No. EL/3.1.35/2/Elect

MODIFICATION SHEET NO. RDSO/2012/EL/MS/0413, Rev. '1' Dated 25.04.2016

Paralleling of interlocks of EP contactors and auxiliary contactors of three phase locomotives to improve reliability.

SCHEMATIC POSITION : 12.3/1
SR Precharging Contactor-1

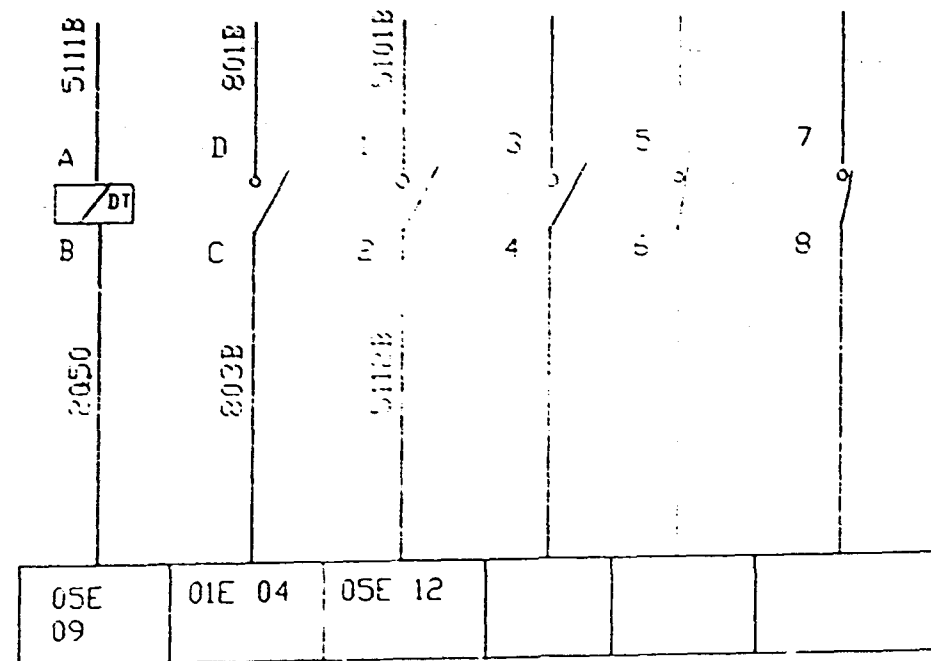
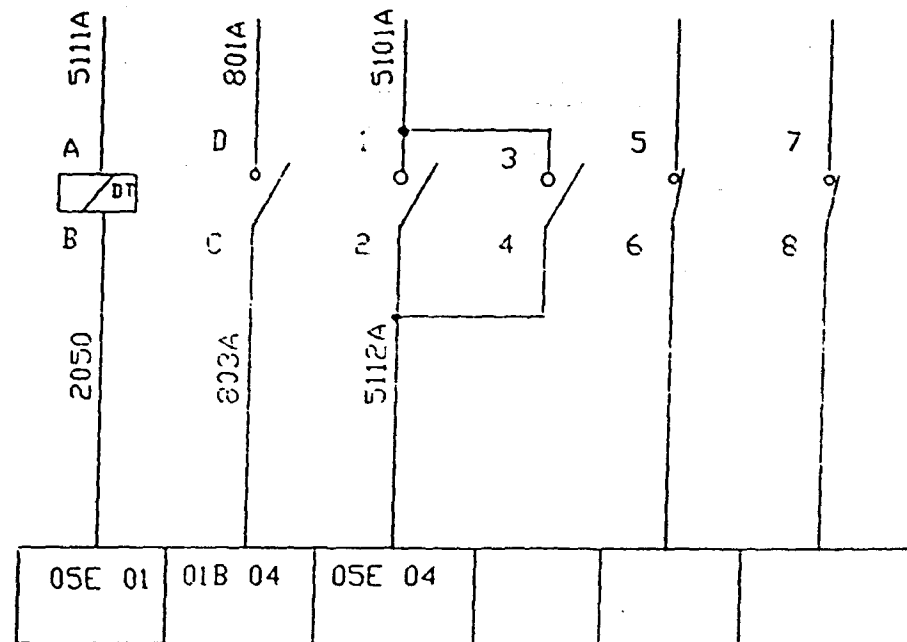
1.	12.3/1 & 2	SR Precharging contactor	0	01 NO	01 NO	SR Cubicle	In type LADN-22, the spare NO interlock 3-4 is to be paralleled with used NO interlock 1-2.

MODIFIED SCHEMATIC POSITION : 12.3/1
SR Precharging Contactor-1

SCHEMATIC POSITION : 52/1
AUXILIARY CONTACTOR

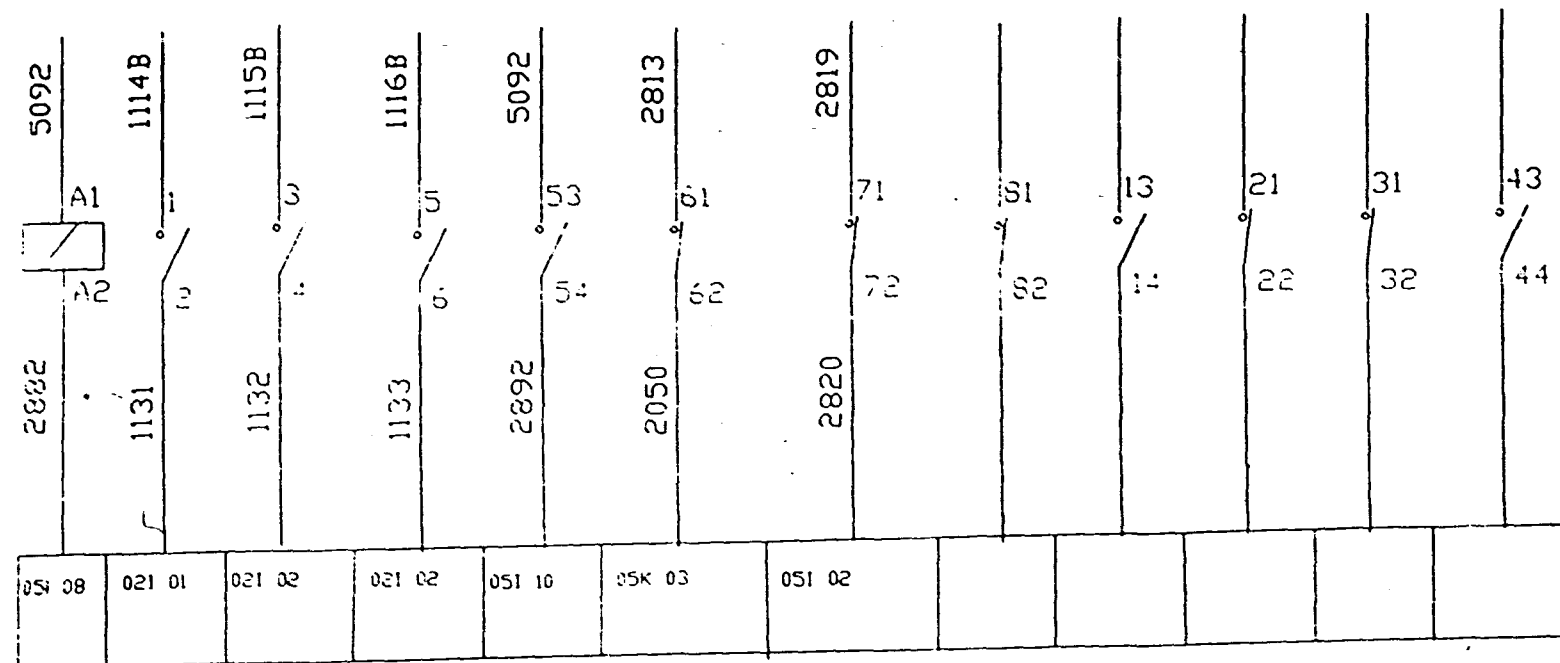
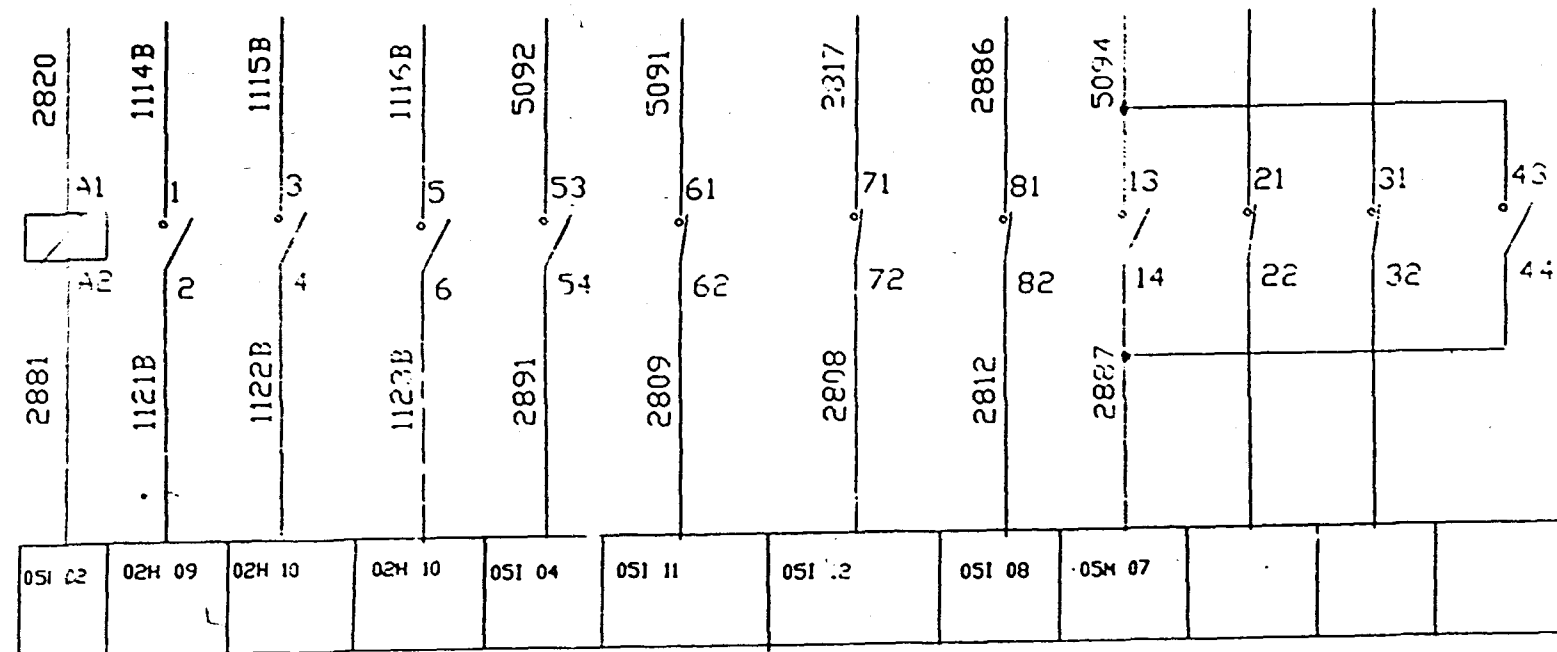
2.	52/1	Auxiliary Contactor	01 NO + 03 NC	01 NO	NIL	01 NO + 02 NC	BUR-2/3	In type LADN-22. The spare NO interlock 43-44 is to be paralleled with used NO interlock 13-14.

MODIFIED SCHEMATIC POSITION : 52/1
AUXILIARY CONTACTOR

SCHEMATIC POSITION : 52/2
AUXILIARY CONTACTOR

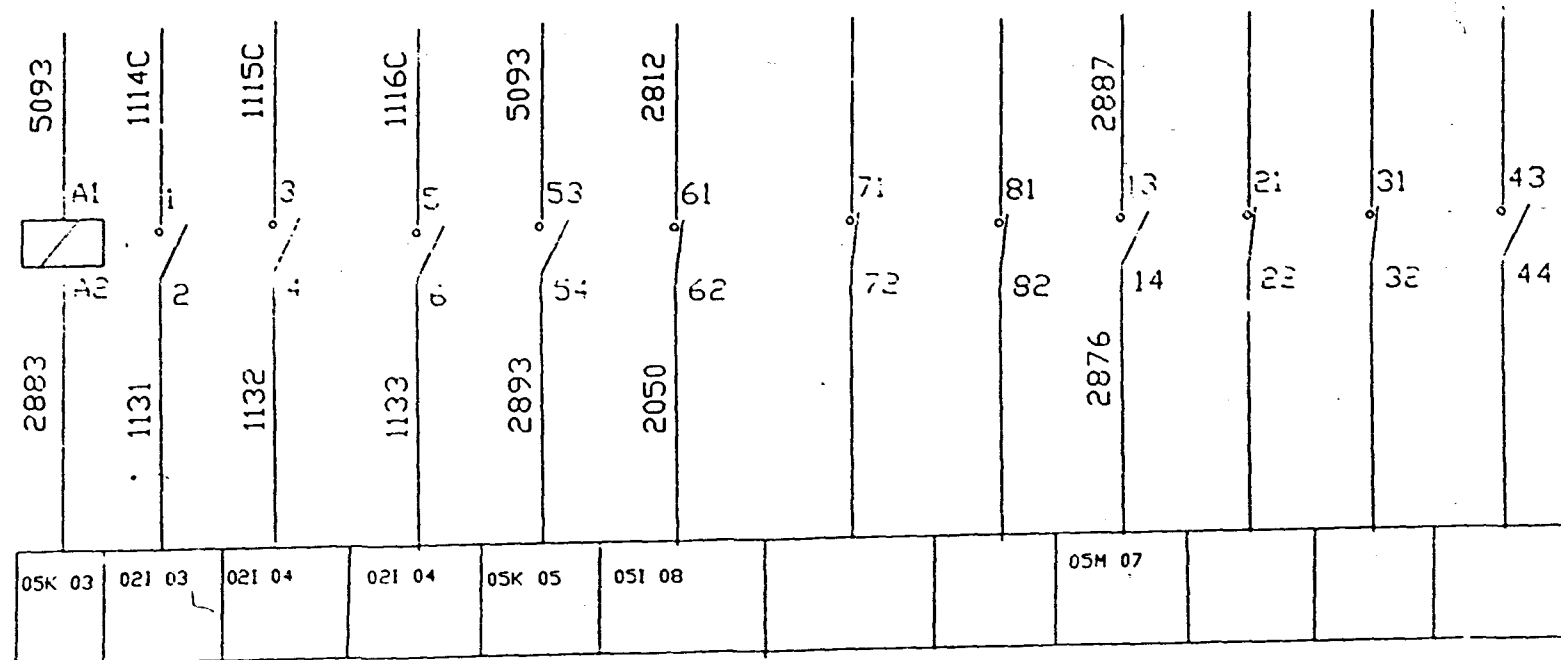
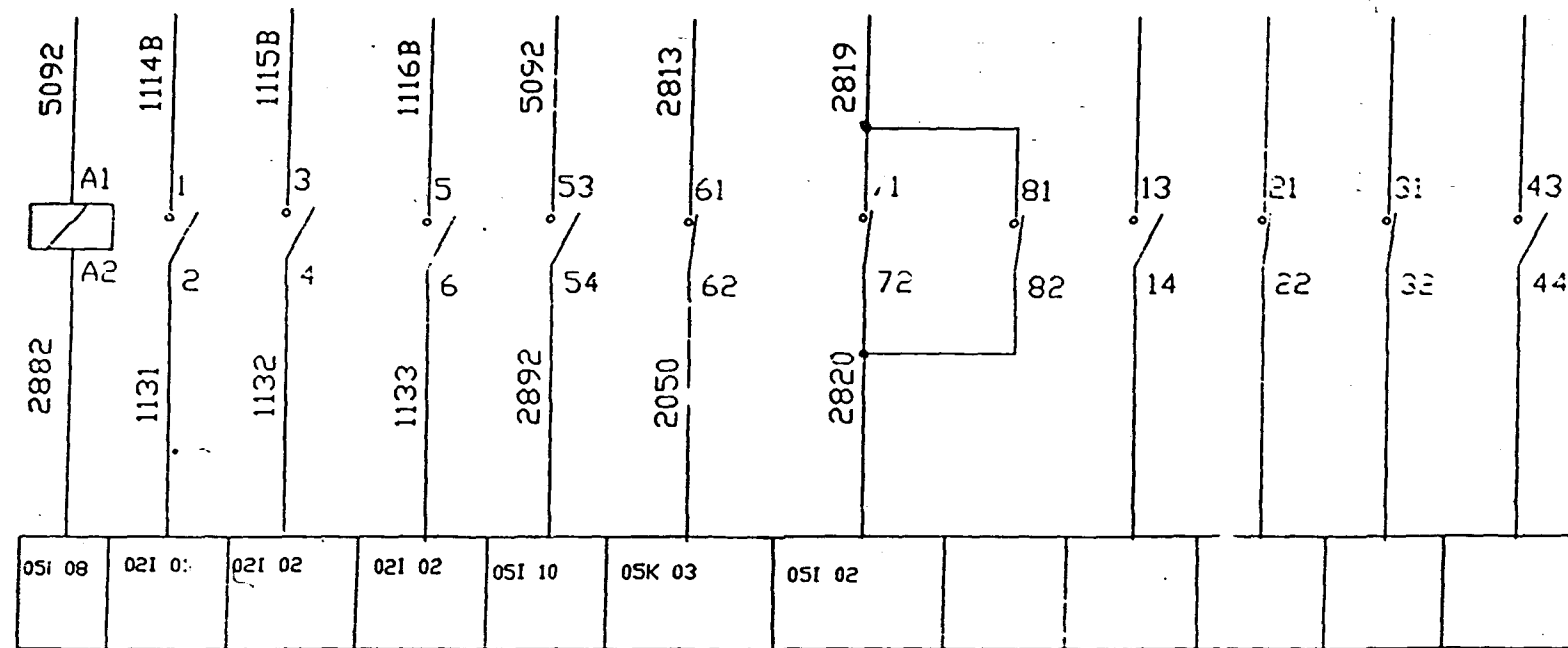
3.	52/2	Auxiliary Contactor	01 NO + 02 NC	Not in service	01 NC	Not in service	BUR-2/3	In type LADN-13. The spare NC interlock 81-82 is to be paralleled with used NO interlock 71-72.

MODIFIED SCHEMATIC POSITION : 52/2
AUXILIARY CONTACTOR

SCHEMATIC POSITION : 52/3
AUXILIARY CONTACTOR

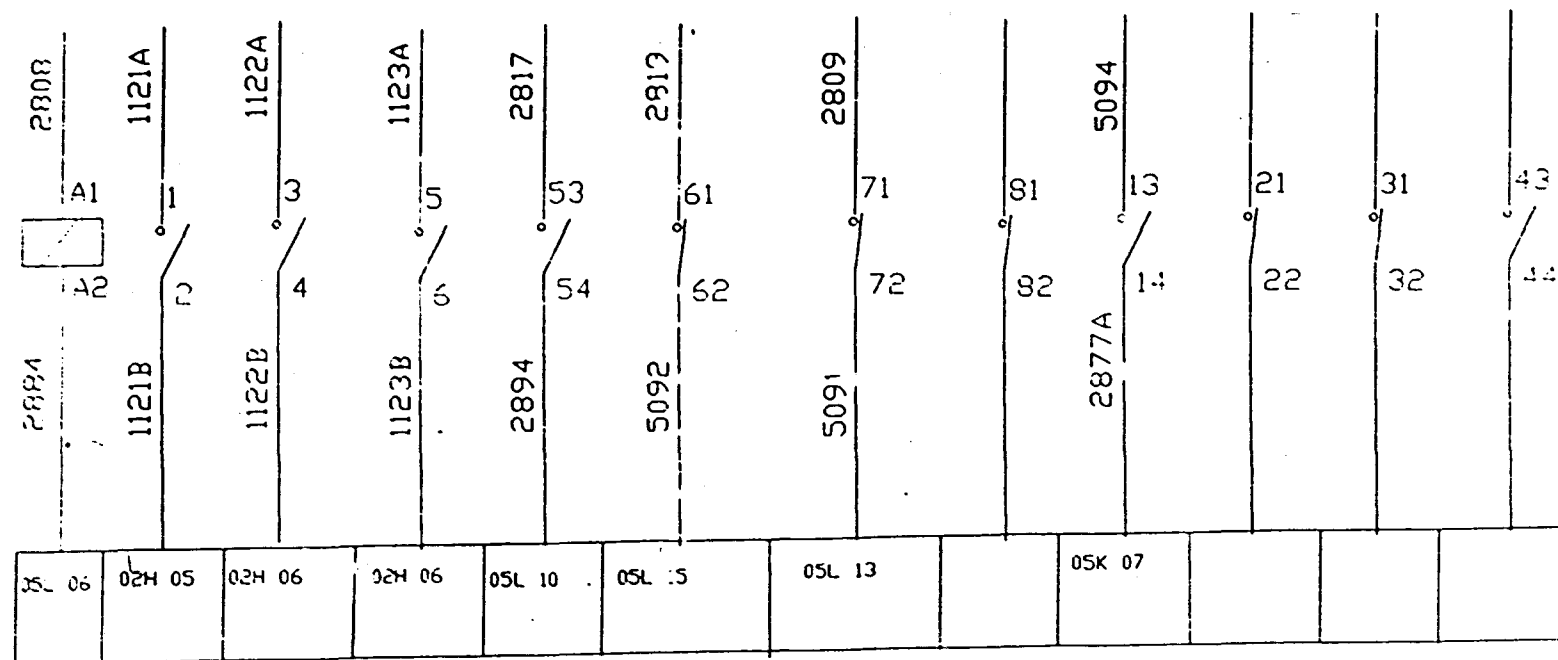
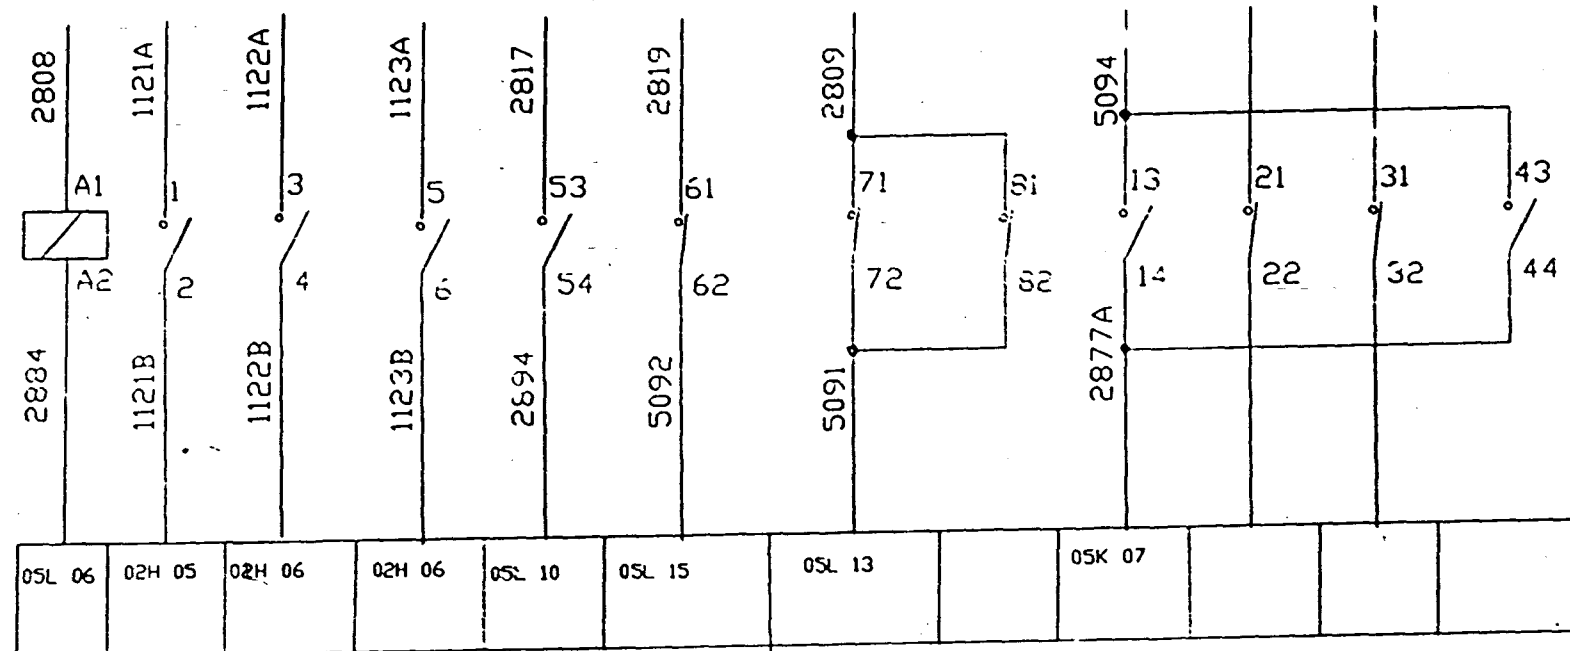
4.	52/3	Auxiliary Contactor	01 NO + 01 NC	02 NO	02 NC	02 NC	BUR-2/3	In type LADN-13 the spare NC I/L 71-72 is to be paralleled with use N/C I/L 61-62. In type LADN-22 the spare NO I/L 43-44 is to be paralleled with used NO I/L 13-14.

MODIFIED SCHEMATIC POSITION : 52/3
AUXILIARY CONTACTOR

SCHEMATIC POSITION : 52/4
AUXILIARY CONTACTOR

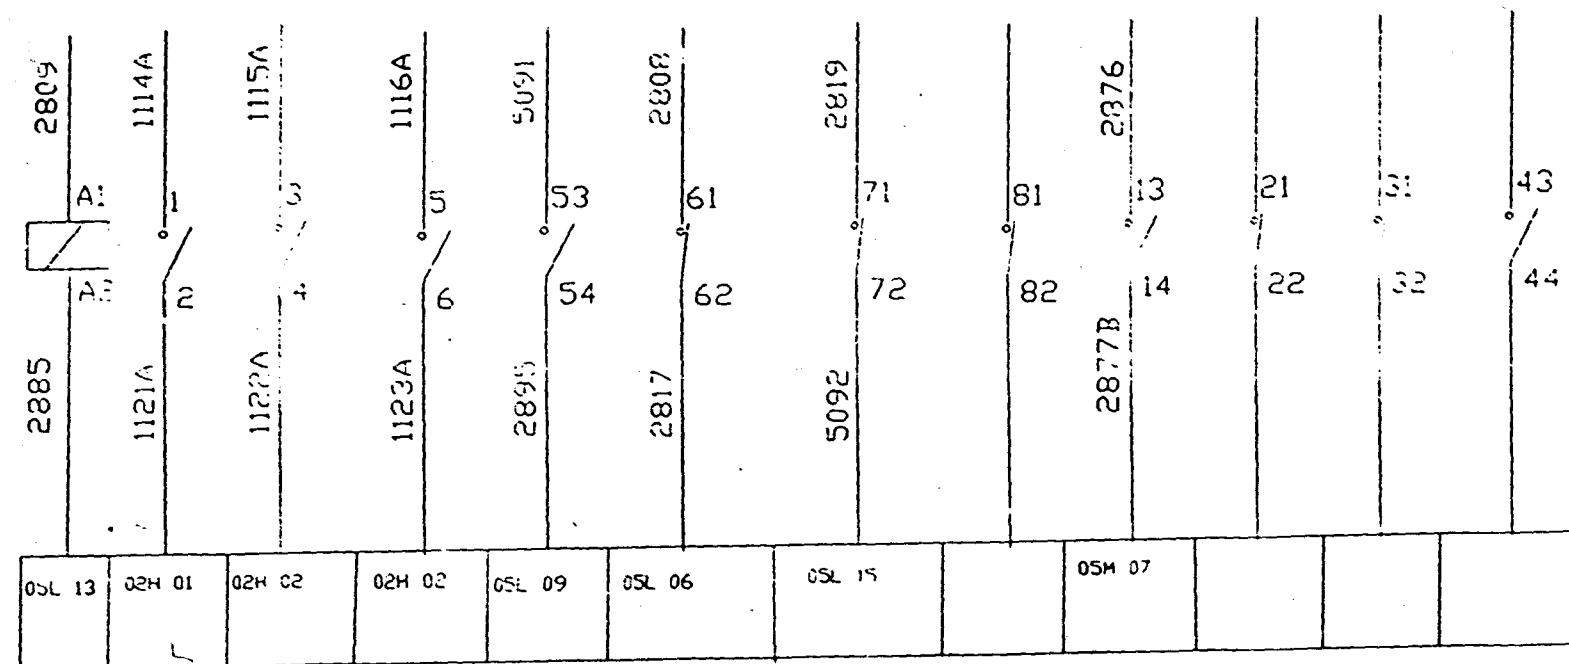
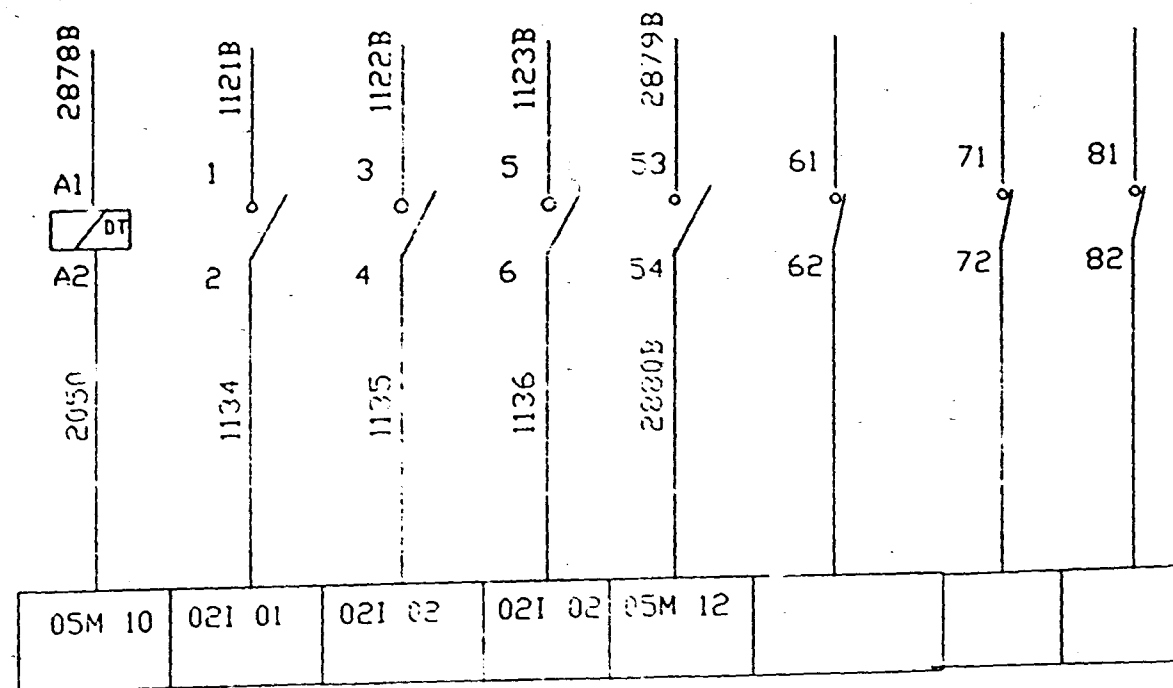
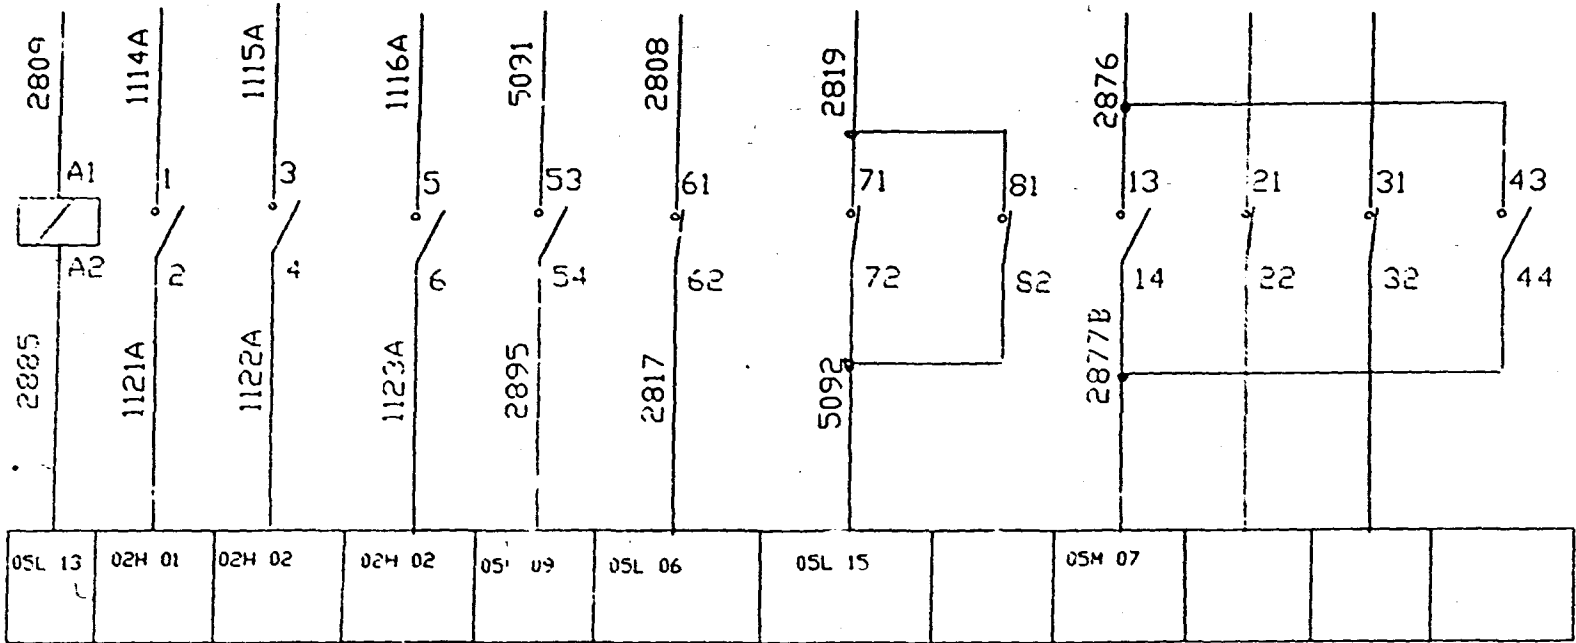
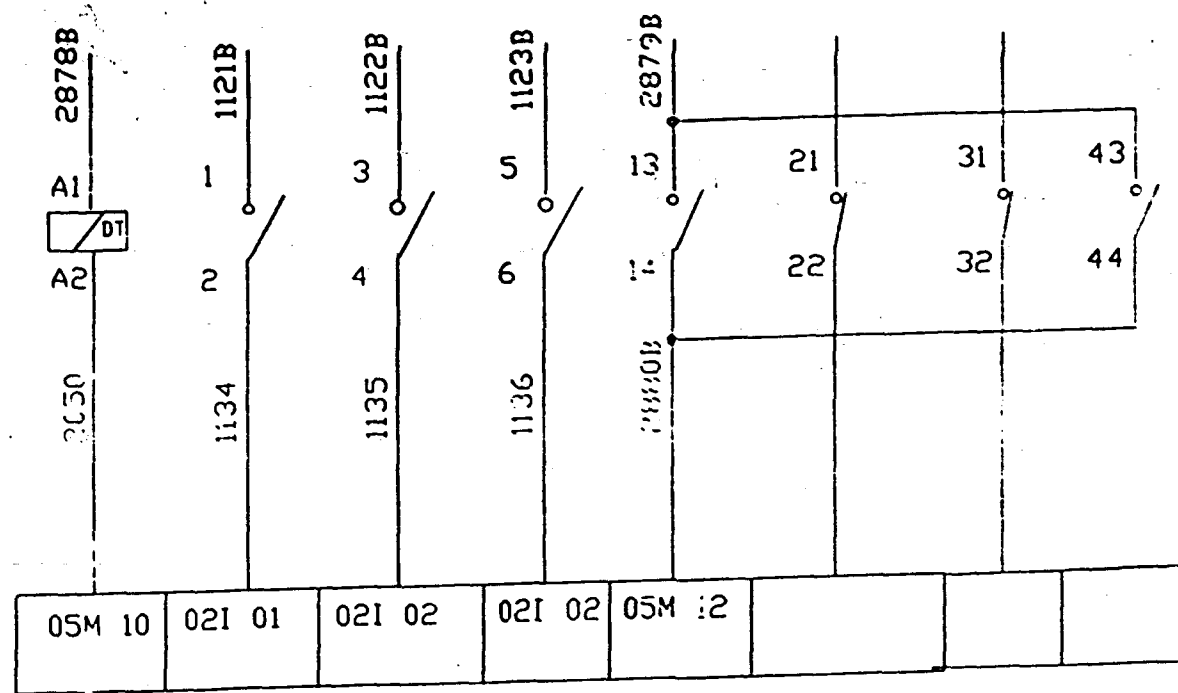
5.	52/4 & 52/5	Auxiliary Contactor	01 NO + 02 NC	01 NO	01 NC	01 NO + 02 NC	HB-1	In type LADN-13 the spare 81-82 NC I/L is to be paralleled with used NC I/L 71-72. In type LADN-22 the spare NO I/L 43-44 is to be

MODIFIED SCHEMATIC POSITION : 52/4
AUXILIARY CONTACTOR

MODIFIED SCHEMATIC POSITION : 52/5
AUXILIARY CONTACTOR
